Philip S Miller Park Phase 2 Construction Project

Description of Work Being Performed: **South Parking Lot Earthwork - Erosion Control - Electrical Relocation**

CHANGE REQUEST #10

TITLE: Revised South Parking Lot
PROJECT: Philip S Miller Park Phase 2
TO: Attn: Mark Zeigler
MW Golden Constructors

Drawing Name:
SOUTH PARKING LOT

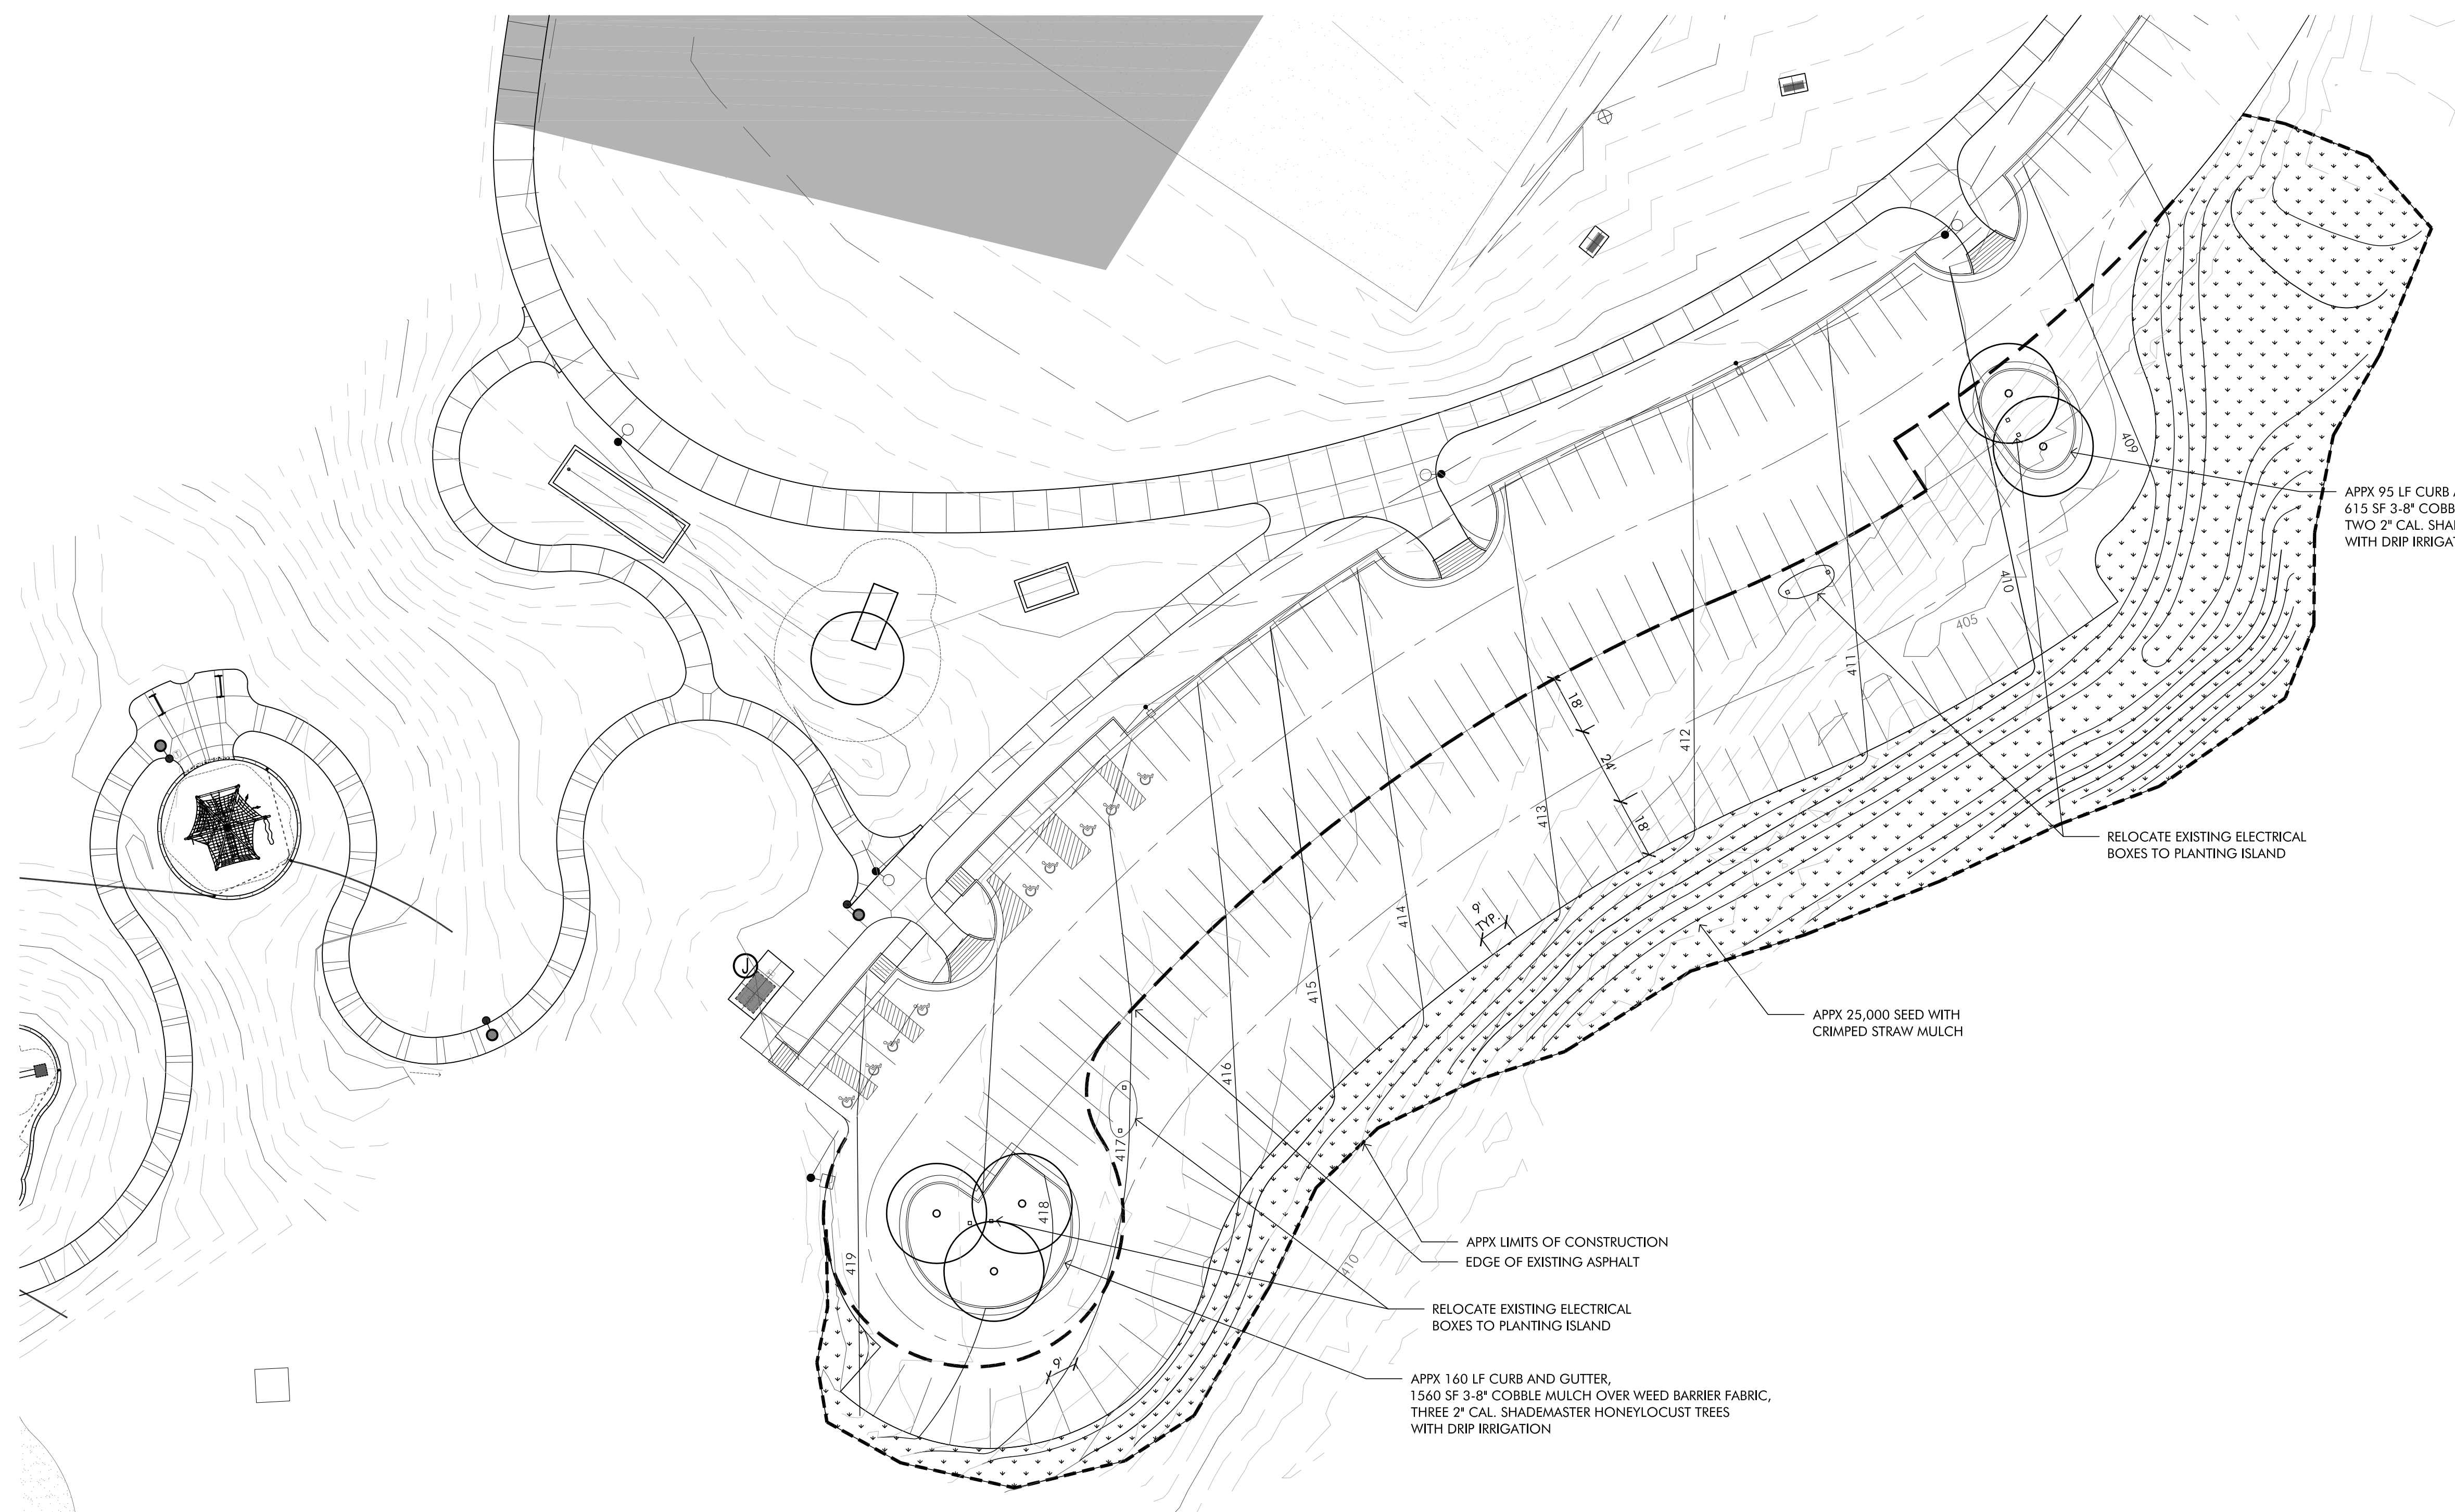
APPX 95 LF CURB AND GUTTER,
615 SF 3-8" COBBLE MULCH OVER WEED BARRIER FABRIC,
TWO 2" CAL. SHADEMASTER HONEYLOCUST TREES
WITH DRIP IRRIGATION

RELOCATE EXISTING ELECTRICAL
BOXES TO PLANTING ISLAND

APPX 25,000 SEED WITH
CRIMPED STRAW MULCH

RELOCATE EXISTING ELECTRICAL
BOXES TO PLANTING ISLAND

APPX 160 LF CURB AND GUTTER,
1560 SF 3-8" COBBLE MULCH OVER WEED BARRIER FABRIC,
THREE 2" CAL. SHADEMASTER HONEYLOCUST TREES
WITH DRIP IRRIGATION

- Relocated Existing conduits by existing South parking lot
 - There are (2) Existing runs this area
 - The first run has the following
 - (1) 2-1/2" PVC Conduit with (3) #6 wire
 - (1) 1" PVC Spare Stubs
 - The Second Conduit has the following
 - (1) 2-1/2" PVC Spare Stubs
 - To reuse existing in ground boxes
 - To cut off and intercept conduits on each end of the parking lot and re tie together by routing around the new parking lot.

This estimate reflects changes to the south parking lot per plans provided by BHA Design dated June 19, 2015. See attachment for breakdown.
